Re: Status of proposed site stabilization plans for Columbia Park sites.

SUBJECT: Status of proposed site stabilization plans for Columbia Park sites

REPATRIATION AND PROTECTION ACTIONS
BONNEVILLE PROJECT

Excavation Detail

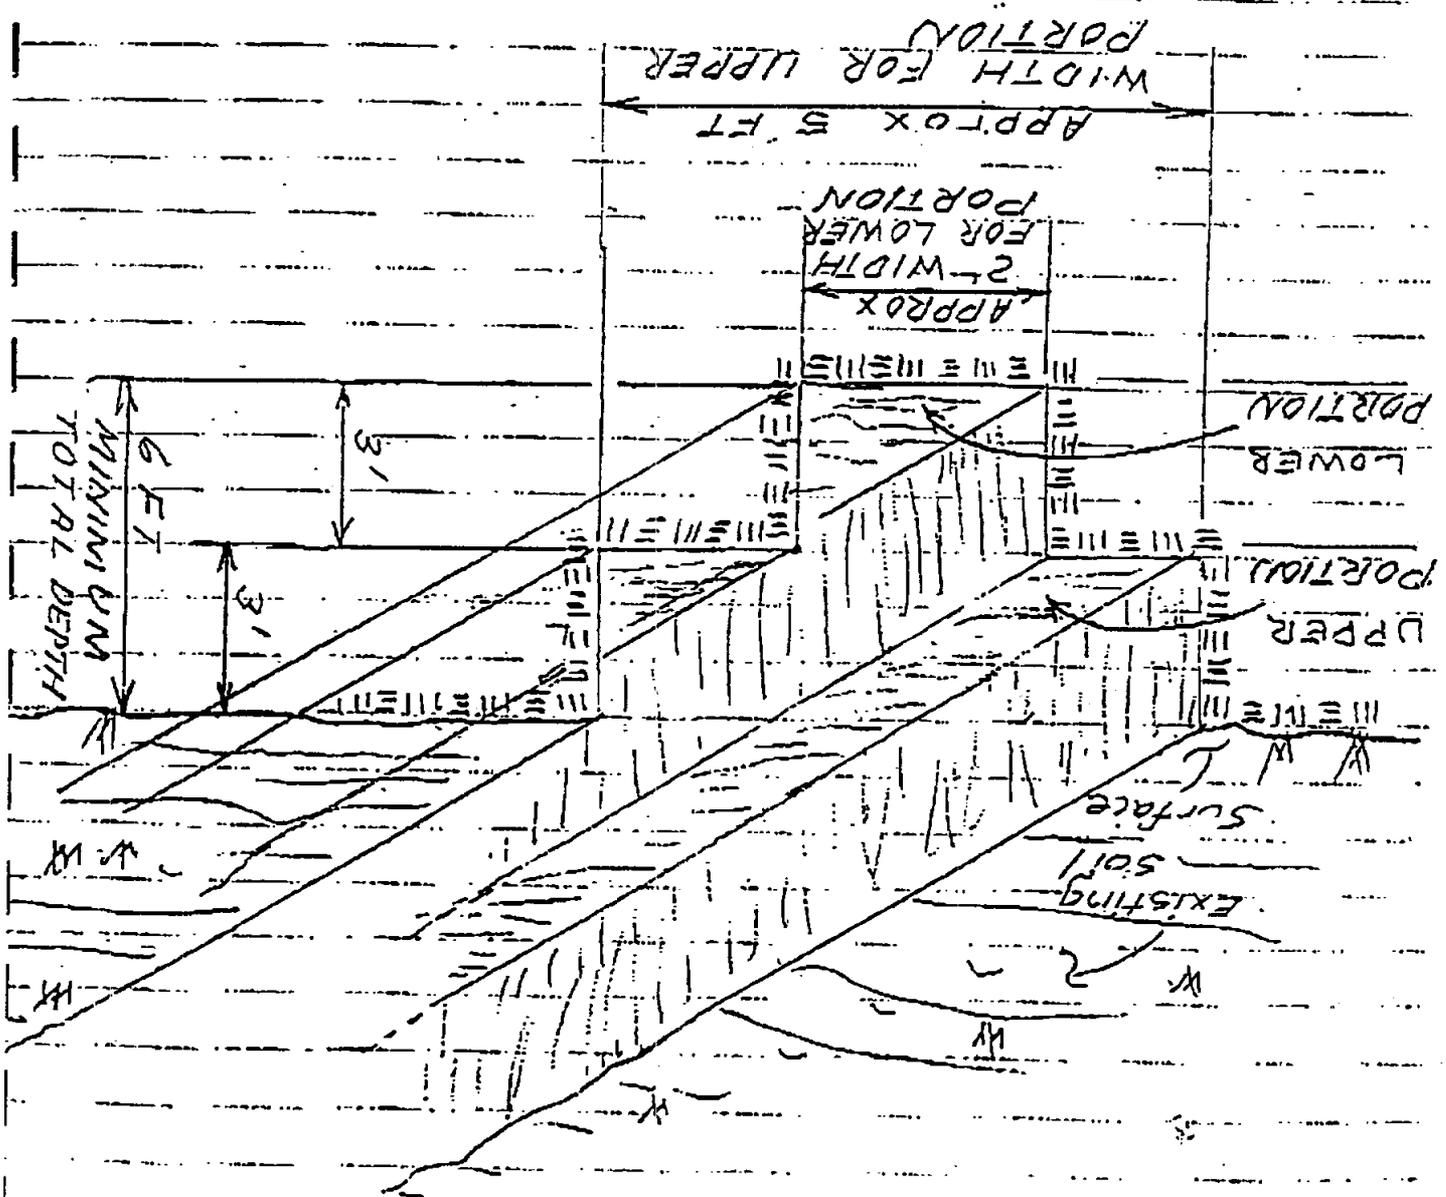
Because the burial protection which will be installed is fairly rigid and measures 10 ft by 2 or 4 ft, it will require the excavation be shaped to accommodate the panel installation without having to perform any substantial amount of hand work or panel alignments. Suggested shape of excavation:

Panels to be installed on either side and on top immediately around the remains are 10 ft by 2 ft, and weigh about 38 lbs each. We are still looking into the method of joining these three-panel sets. Be aware that the joining process would take a lot of time, since it involves a large number of separate connections. What tools are available for making connections?

Panels to be installed above the three-panel sets are 4 ft by 10 ft and weigh about 76 lbs each. They will be placed 3 ft above the remains, and 3 ft below the ground surface in a wider excavation. Four by ten panels are to be joined end-to end.
